R09PD

Blue Bird has decided that a defect which relates to motor vehicle safety exists on certain 2008 and 2009 model year "Vision" conventional school buses manufactured from January 18, 2007 through October 29, 2008 and equipped with Caterpillar C7 and C7 07 engines.

Fan Clutch Spacers

MODELS AFFECTED: 2008-2009 BBCV Visions w/ 2007 Cat Engines

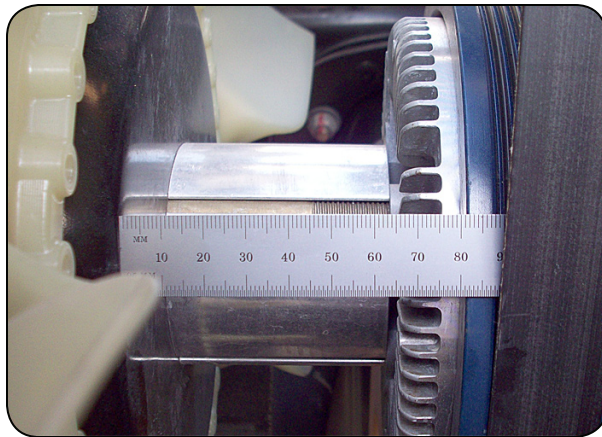
Fan may separate from fan clutch and may damage fans blades, fan clutch, radiator, hoses and other surrounding components.

Inspect fan spacer length and install new spacer and bolts as required.

Inspection

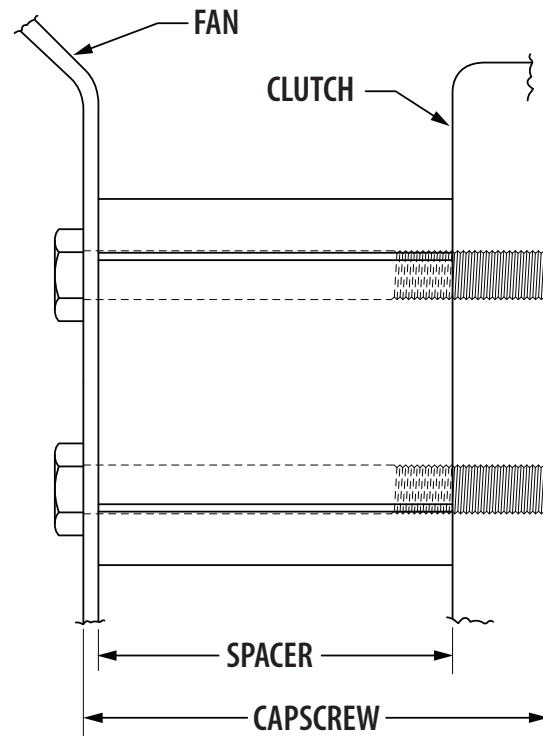
- 1 Park vehicle on a level surface, apply parking brake, turn engine off, remove ignition key and chock wheels.
- 2 Disconnect batteries.
- 3 Open engine hood.
- 4 Measure the length of the spacer between the fan blade and the fan clutch. See Diagram and Chart to the right for correct installations and determine procedure needed.

ENGINE	SPACER	CAPSCREW
CAT C707 with CGI & DPF	66.7mm (2 5/8 inches)	90mm M10-1.5 X 90mm
CAT C7 or Export without CGI & DPF	52.8mm (2 5/64 inches)	70mm M10-1.5 X 70mm
